AREVA Report ANP-2992NP, Revision 0,
AREVA Response to Additional RAI on the Brunswick RODEX4 LAR

AREVA Response to Additional RAI on the Brunswick RODEX4 LAR

REQUEST FOR ADDITIONAL INFORMATION
BRUNSWICK STEAM ELECTRIC PLANT UNITS 1 AND 2
REQUEST FOR LICENSE AMENDMENTS
ADDITION OF ANALYTICAL METHODOLOGY TOPICAL REPORTS
TO TS 5.6.5, CORE OPERATING LIMITS REPORT
(ME3858 and ME3859)

Figure 11 Ductility of irradiated cladding vs. H concentration (Reference 9)

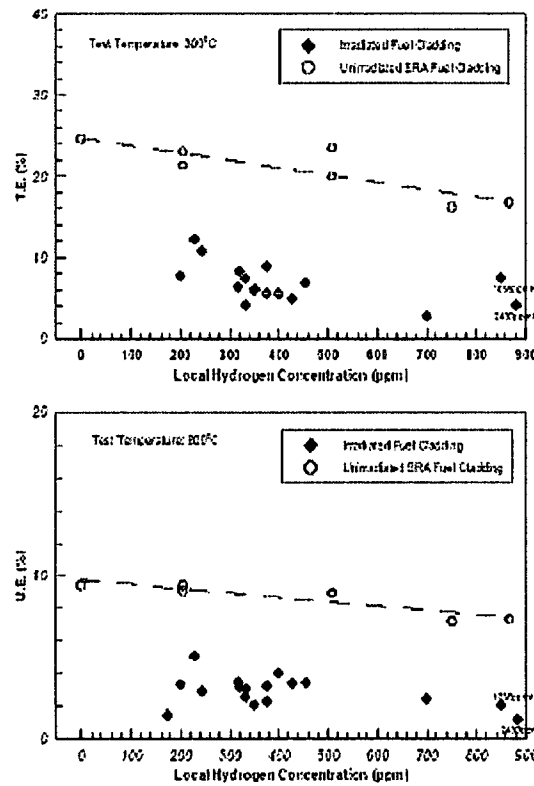
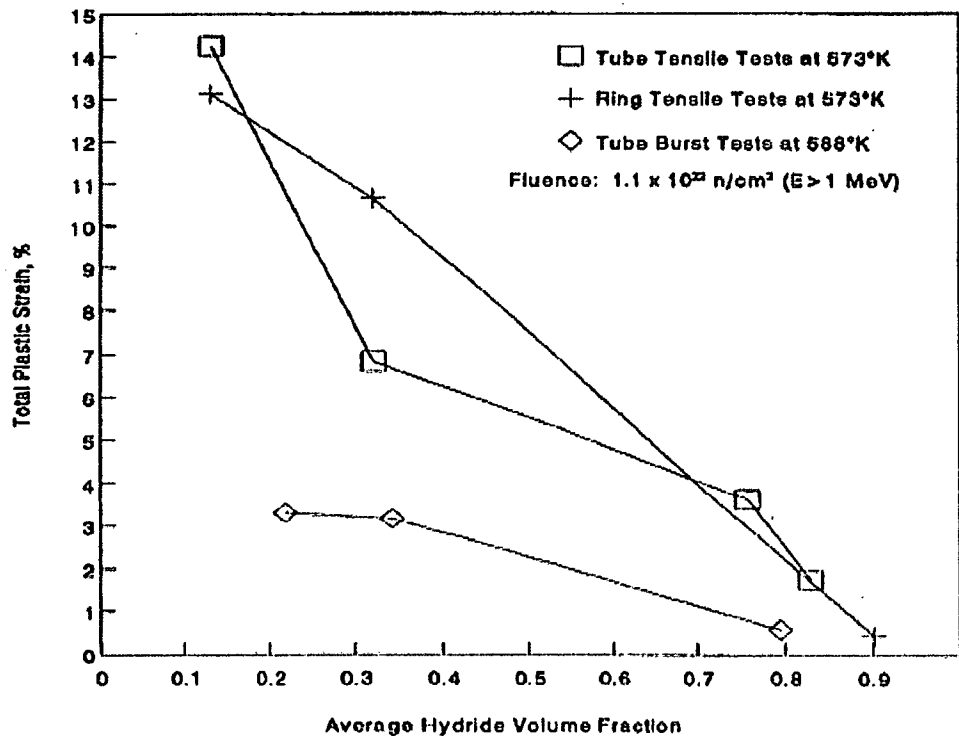
The studies presented in References 9 and 10 are illustrated in Figure 6 of Reference 9 and Figure 7 of Reference 10, which are reproduced below as Figure 11 and Figure 12. These studies show that sufficient [

Both papers conclude that H content of the cladding at operating temperatures has negligible impact on cladding ductility and strength (being overshadowed by irradiation hardening) up to very high H concentration levels. This conclusion is summarized in Reference 10, as described below.

Figure 13 Results of PNNL ductility model

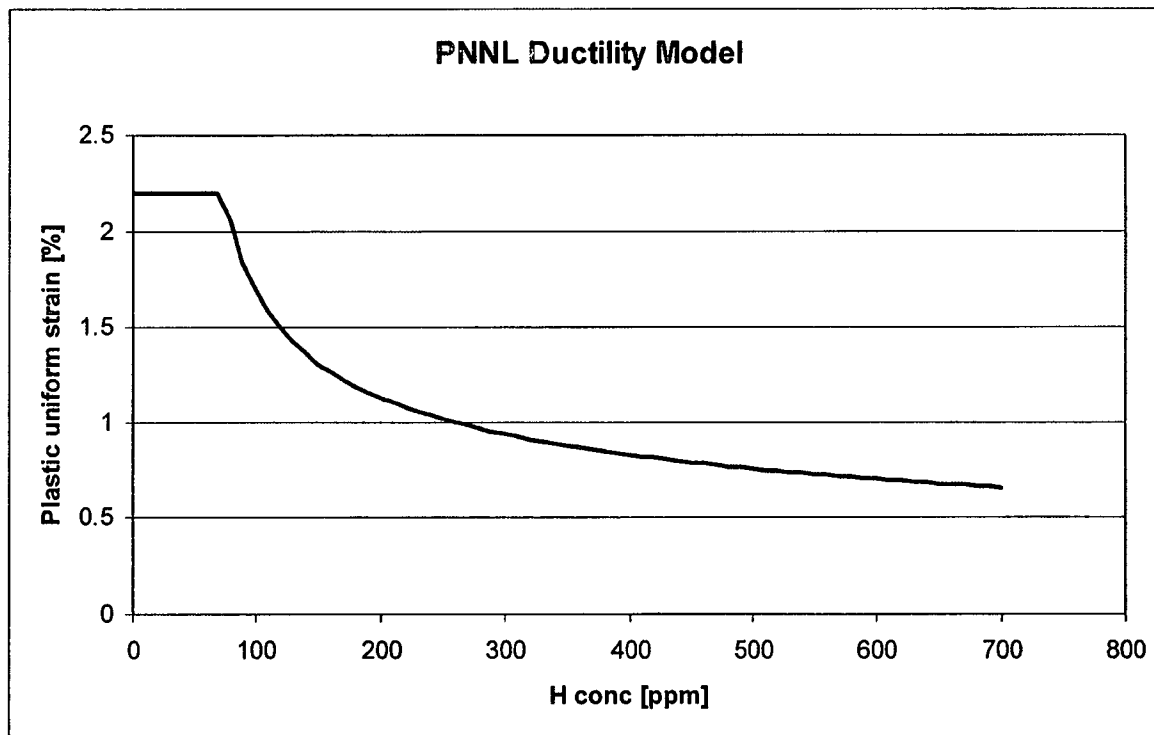
Estimations of the clad ductility based on that PNNL model developed for the NRC in Reference 11 were made and presented below. The model estimates the uniform hoop strain as dependent on H concentration and temperature. Assuming a conservative lower bound temperature of the clad of 554 K, Figure 13 below shows the results.

A lower bound value of the irradiated yield strength is [] MPa at a corresponding elastic strain greater than [] %, based on AREVA NP test data obtained at ~300 °C. The uniform strain capability of the cladding (i.e., [] % elastic strain plus plastic strain from Figure 13) exceeds 1% with no hold time at high H concentrations. Even accounting for a hold time that would convert some of the elastic strain into plastic, the uniform strain capability of the cladding will exceed the SRP 4.2 criterion at a H pick-up of [] ppm.
